6) A Portion Of The New Firebox Was Replaced With Flat Plate In A Tight Radius

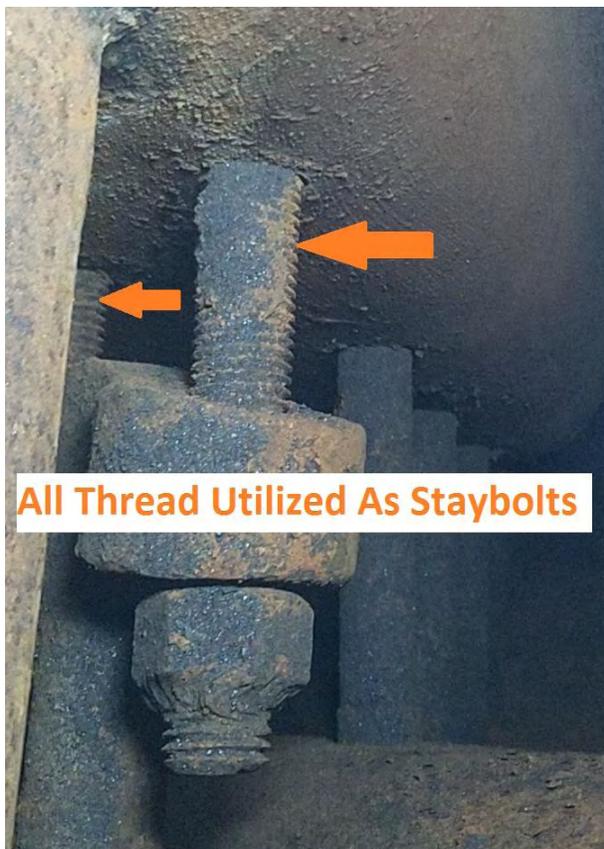
A sharply radiused portion of the new firebox was cut out and replaced with a piece of flat plate. This is contrary to O.E.M. design and violates railroad standard practice, and NBIC code. PW-9.3.1 states that the “middle lines” of the plate are to be aligned, these are not as one is radiused and the other straight. When replacing a portion of any boiler it is to be replaced “in kind” to the original. This in turn violates CFR49 Part 230.29 (b) (1).
